INCH-POUND
MIL-H-83511/5
AMENDMENT 1
15 October 1999

MILITARY SPECIFICATION SHEET

HEADSET-MICROPHONE
H-172A/AIC

This amendment forms part of Military Specification Sheet MIL-H-83511/5, dated 04 April 1978, and is approved by all Departments and Agencies of the Department of Defense.

Alternate locking thumbnut configuration.

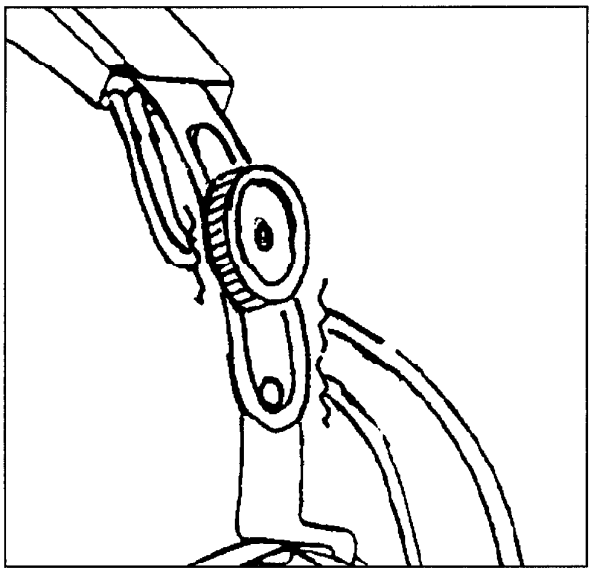
FIGURE 1: Add to Figure 1: Alternate configuration to the sliding action is a positive locking thumbnut.

FIGURE 3. Wiring diagram (H-172A/AIC).

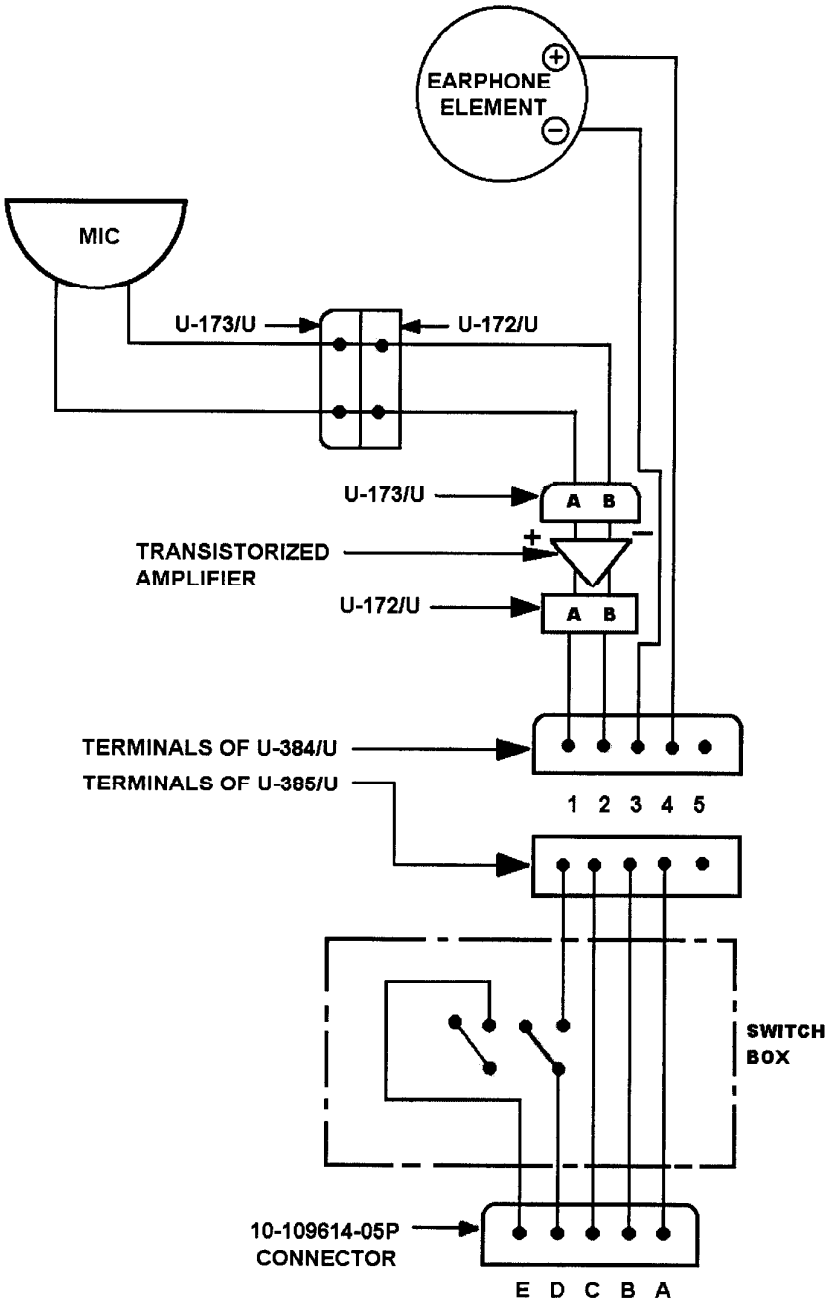
Figure 3: Delete and substitute:
